NACELLE - POWER PLANT - PIPE ASSEMBLY, OIL TANK SCUPPER DRAIN - REPLACEMENT OF -
CATEGORY CODE 7 - MOD.NAC-71-0047

V2500-NAC-71-0047

SERVICE BULLETIN

Location of Oil Tank Scupper Drain Pipe Assembly and Its Clipping Points
Fig.1

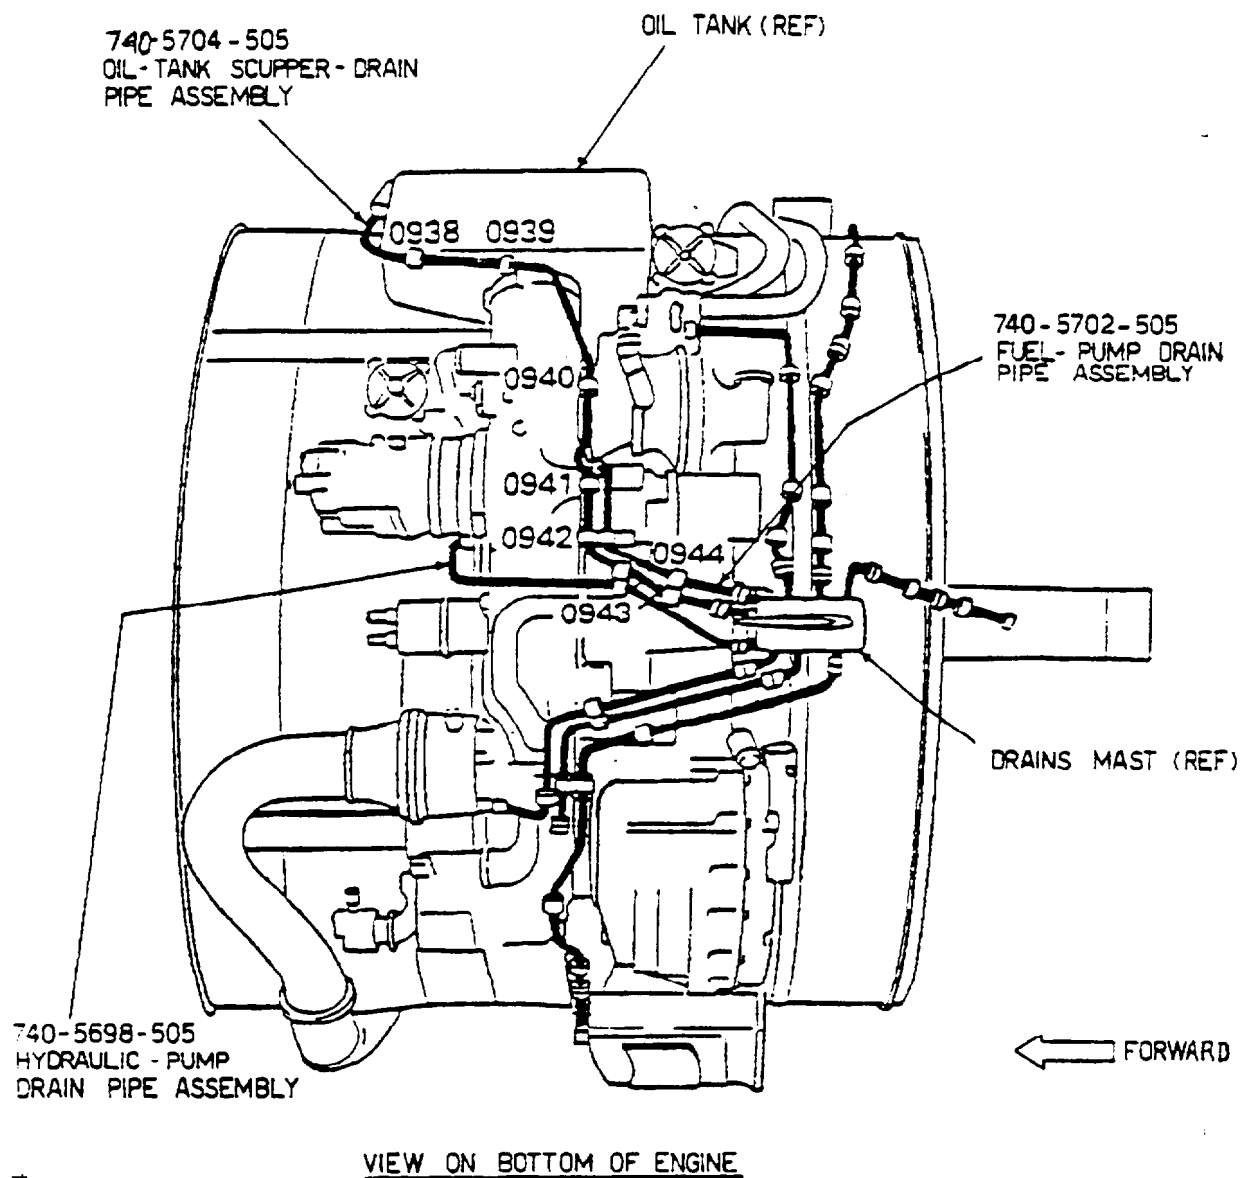
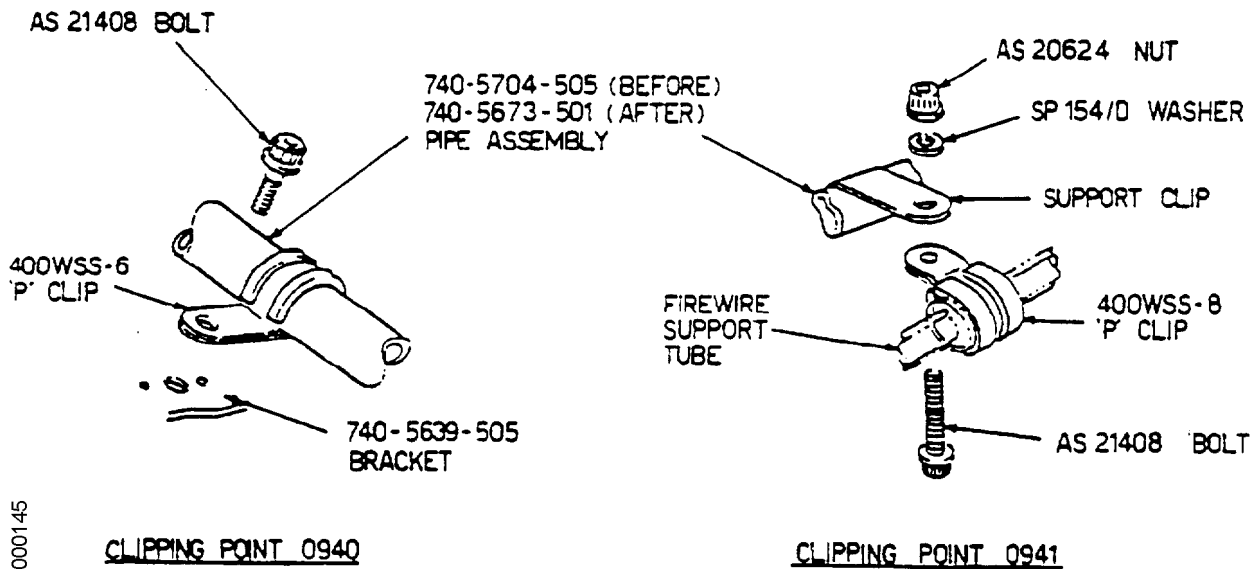
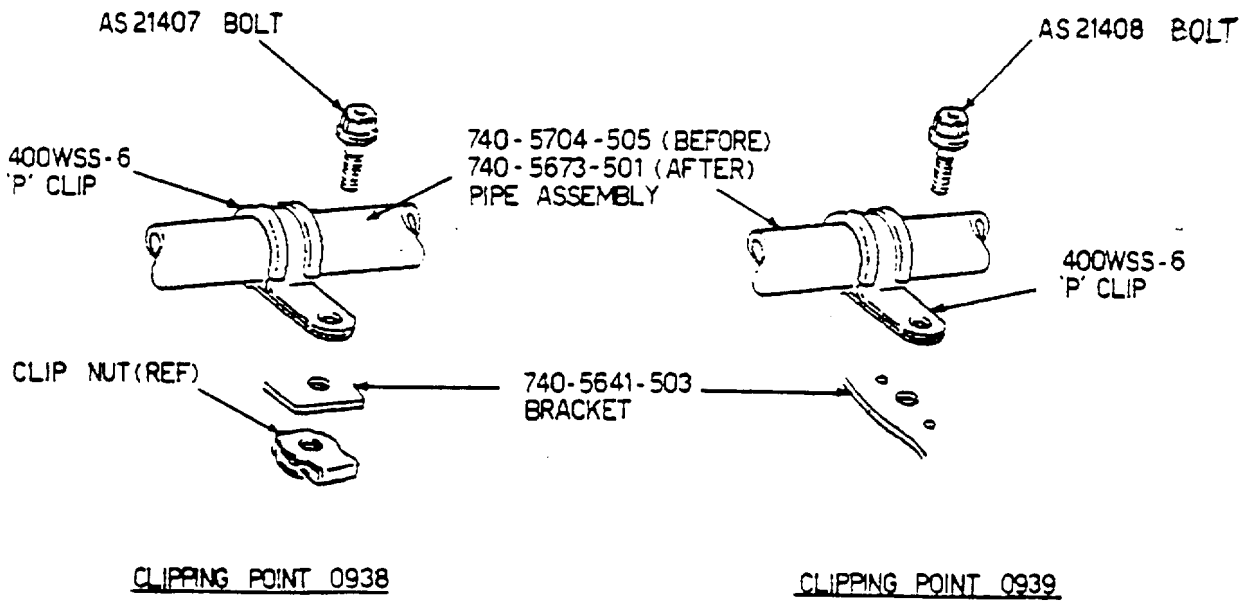
(1) Find the 740-5704-505 oil-tank, scupper-drain pipe assembly which goes from the oil tank to the drains mast. (Refer to Figure 1.)

(2) Remove the seven clipping points which hold the 740-5704-505 pipe assembly as follows: (refer to Figures 1, 2, and 3.)

Removal/Installation of Clipping Points 0938 thru 0941
Fig.2

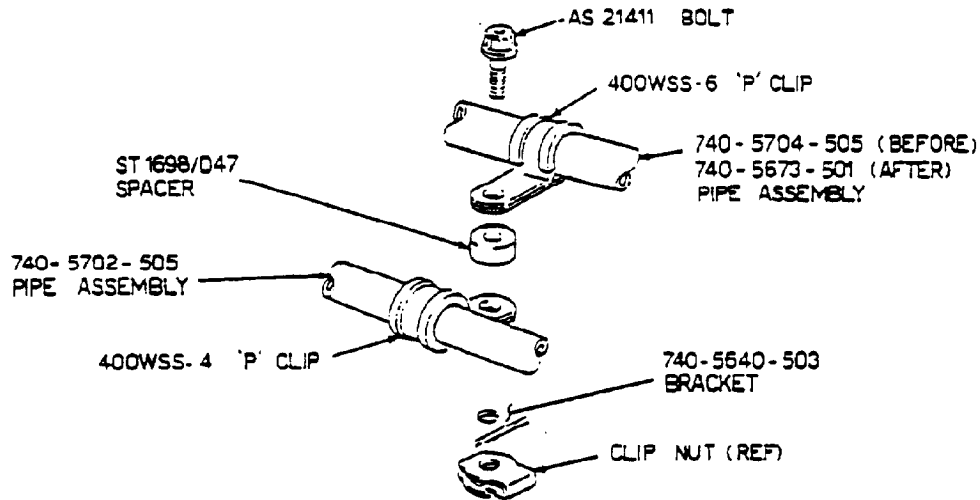
(a) Find clipping point 0938. Remove the AS21407 bolt which attaches the 400WSS-6 'P' clip to the 740-5641-503 bracket. Remove the 'P' clip from the 740-5704-505 pipe assembly.

(b) Find clipping point 0939. Remove the AS21408 bolt which attaches the 400WSS-6 'P' clip to the 740-5641-503 bracket. Remove the 'P' clip from the 740-5704-505 pipe assembly.

(c) Find clipping point 0940. Remove the AS21408 bolt which attaches the 400WSS-6 'P' clip to the 740-5639-505 bracket. Remove the 'P' clip from the 740-5704-505 pipe assembly.

- (d) Find clipping point 0941. Remove the AS21408 bolt, the SP154-D washer and the AS20624 nut. These attach the 400WSS-8 'P' clip to the support clip on the 740-5704-505 pipe assembly. Let the 'P'clip stay on the firewire support tube.

- (d) Find the 400WSS-8 'P' clip which holds the firewire support tube at the position where clipping point 0941 was. (Refer to paragraph 2.A.)(3)(d)). Attach this 'P' clip to the support clip on the 740-5673-501 pipe assembly. Use an AS21408 bolt, an SP154-D washer, and an AS20624 nut.

- (e) Put a 400WSS-6 'P' clip around the 740-5673-501 pipe assembly at the position where clipping point 0940 was. Attach this 'P' clip to the 740-5639-505 bracket with an AS21408 bolt.

- (f) Put a 400WSS-6 'P' clip around the 740-5673-501 pipe assembly at the position where clipping point 0939 was. Attach this 'P' clip to the 740-5641-503 bracket with an AS21408 bolt.

- (g) Put a 400WSS-6 'P' clip around the 740-5673-501 pipe assembly at the position where clipping point 0938 was. Attach this 'P' clip to the 740-5641-505 bracket with an AS21407 bolt.

Removal/Installation of Clipping Points 0942, 0943, and 0944
Fig.3

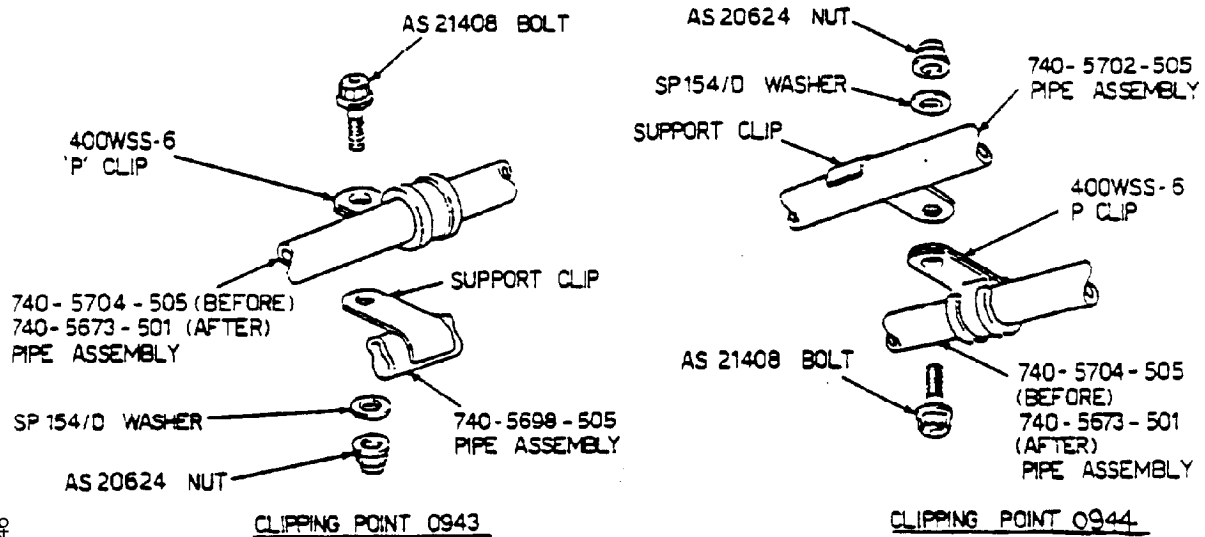
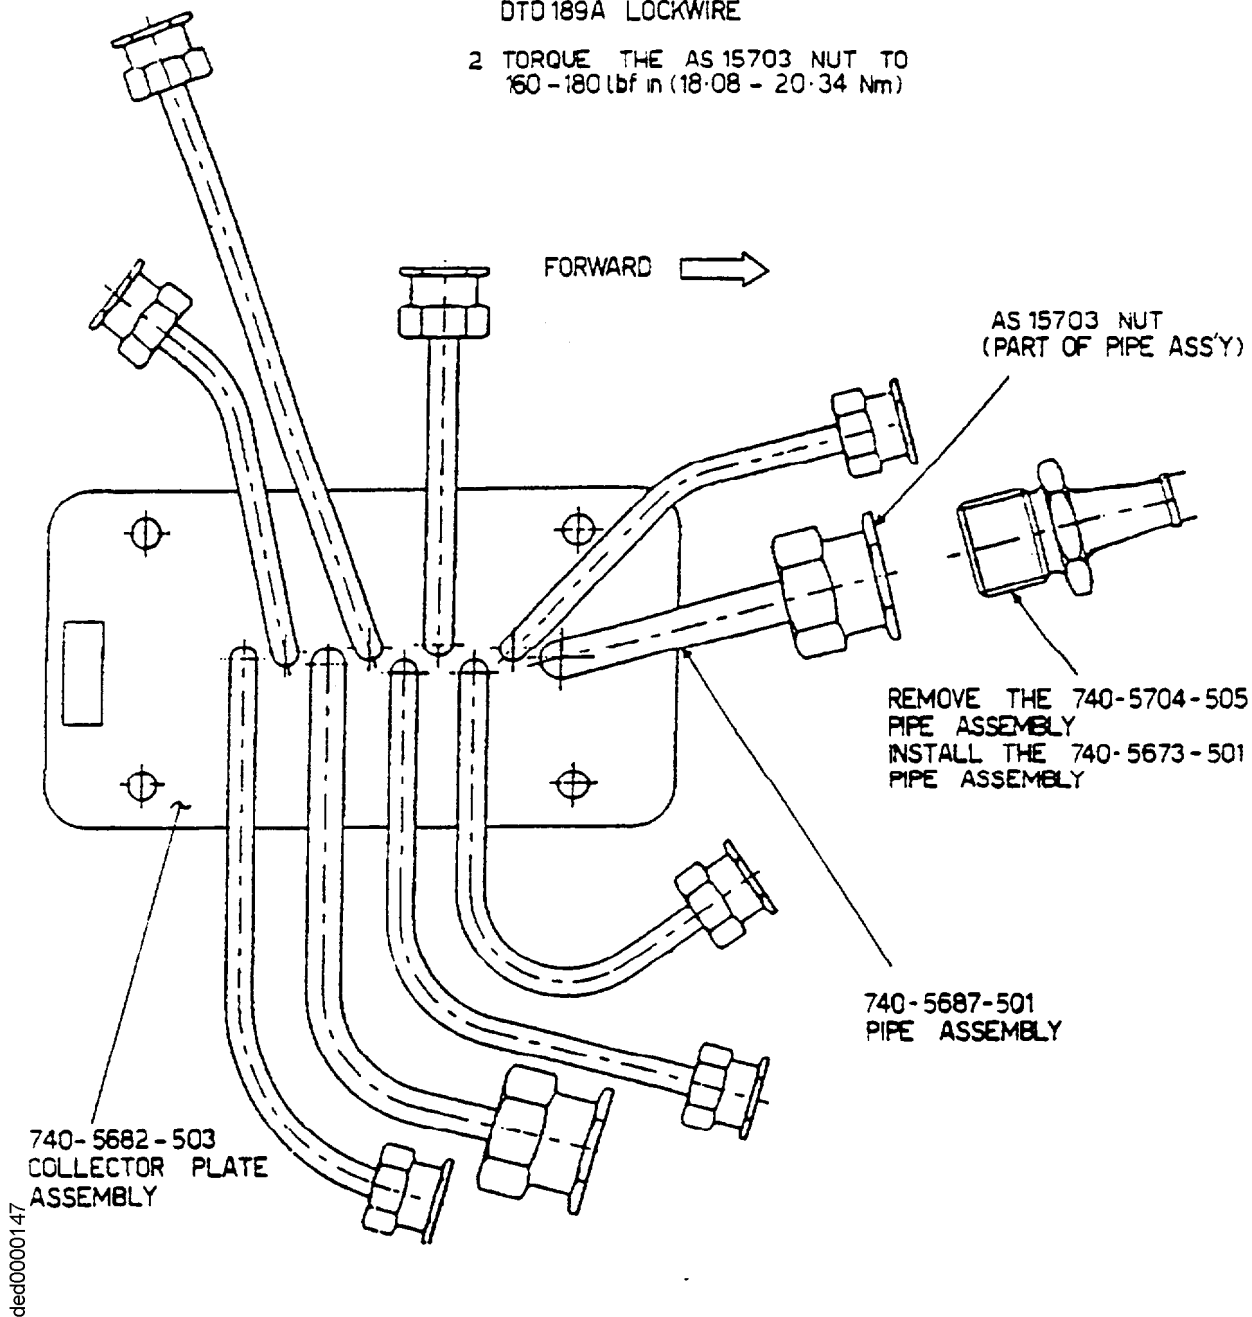
- (e) Find clipping point 0942. Remove the AS21411 bolt which attaches the 400WSS-6 and the 400WSS-4 'P' clip to the 740-5640-503 bracket. Remove the ST1698-D47 spacer. Remove the 400WSS-6 'P' from the 740-5704-505 pipe assembly. Let the 400WSS-4 'P' clip stay on the 740-5702-505 fuel-pump-drain pipe assembly.

- (f) Find clipping point 0943. Remove the AS21408 bolt, the SP154-D washer, and the AS20624 nut. These attach the 400WSS-6 'P' clip to the support clip on the 740-5698-505 hydraulic-pump-drain pipe assembly. Remove the 'P' clip from the 740-5704-505 pipe assembly.

- (g) Find clipping point 0944. Remove the AS21408 bolt, the SP154-D washer, and the AS20624 nut. These attach the 400WSS-6 'P' clip to the support clip on the 740-5702-505 pipe assembly. Remove the 'P' clip from the 740-5704-505 pipe assembly.

- (a) Put a 400WSS-6 'P' clip around the 740-5673-501 pipe assembly at the position where clipping point 0944 was. Attach this 'P' clip to the support clip on the 740-5702-505 pipe assembly. Use an AS21408 bolt, an SP154-D washer, and an AS20624 nut.

- (b) Put a 400WSS-6 'P' clip around the 740-5673-501 pipe assembly at the position where clipping point 0943 was. Attach this 'P' clip to the support clip on the 740-5698-505 pipe assembly. Use an AS21408 bolt, an SP154-D washer, and an AS20624 nut.

- (c) Put a 400WSS-6 'P' clip around the 740-5673-501 pipe assembly at the position where clipping point 0942 was. Put the ST1698-D47 spacer between this 'P' clip and the 400WSS-4 'P' clip which stayed on the 740-5702-505 pipe assembly. (Refer to paragraph 2.A.)(3)(e)). Attach these two 'P' clips to the 740-5640-503 bracket with an AS21411 bolt.

Removal/Installation of the Oil Tank Scupper Pipe Assembly (Oil Tank End)
Fig.5

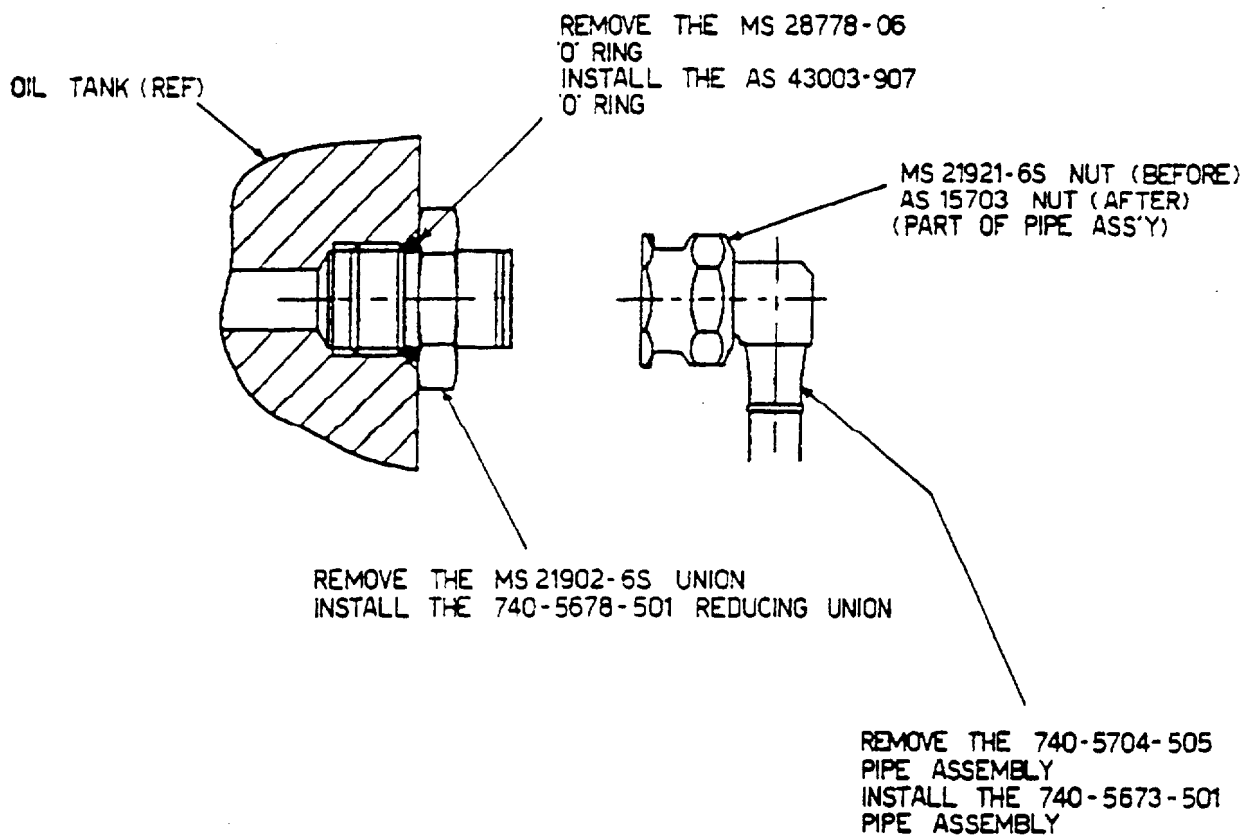
- (c) Loosen the MS21921-6S nut which connects the 740-5704-505 pipe assembly to the MS21902-6S union at the oil tank. (Refer to Figure 5.)
 - (d) Remove the 740-5704-505 pipe assembly. Discard the pipe assembly.

(4) Replace the union at the oil tank interface as follows:
(Refer to Figure 5.)

- (a) Remove the MS21902-6S union from the oil tank. Discard the the union and the MS28778-02 O-ring.
- (b) Lubricate the new AS43003-907 O-ring with Co Mat V10-039 engine oil. (Refer to the V2500 Aircraft Maintenance Manual, Section 70-30-00.) Put the O-ring on the small diameter end of the 740-5678-501 reducing union.

- 1 SAFETY THE AS15703 NUT WITH
OTO 189A LOCKWIRE
- 2 TORQUE THE AS15703 NUT TO
160 - 180 lbf in (18.08 - 20.34 Nm)
- 3 TORQUE THE 740-5678-501 UNION
TO 215 - 245 lbf in (24.295 - 27.685 Nm)

- (c) Install the 740-5678-501 reducing union in the new oil tank.
- (d) Torque the reducing union to 215-245 lb-in. (24.295-27.685 N.m) as specified in the V2500 Aircraft Maintenance Manual, Task 70-23-11-911-010.

- (a) Set the 740-5673-501 pipe assembly in position.
- (b) Connect the 740-5673-501 pipe assembly to the 740-5678-501 reducing union at the oil tank. Hand tighten the AS15703 nut to the reducing union. (Refer to Figure 5.)
- (c) Connect the 740-5673-501 pipe assembly to the 740-5687-501 pipe assembly at the drains mast. Hand tighten the AS15703 nut. (Refer to Figure 4.)

- (d) Torque the AS15703 nuts at each end of the pipe assembly to 160-180 lb-in. (18.08-20.34 N.m) as specified in the V2500 Aircraft Maintenance Manual, Task 70-23-11-911-010.
 - (e) Safety the end couplings of the pipe assembly with DTD189A lockwire as specified in the V2500 Aircraft Maintenance Manual, Task 70-40-11-911-012.
- (6) Install the seven clipping points which will hold the 740-5673-501 pipe assembly as follows: (Refer to Figures 2 and 3.)
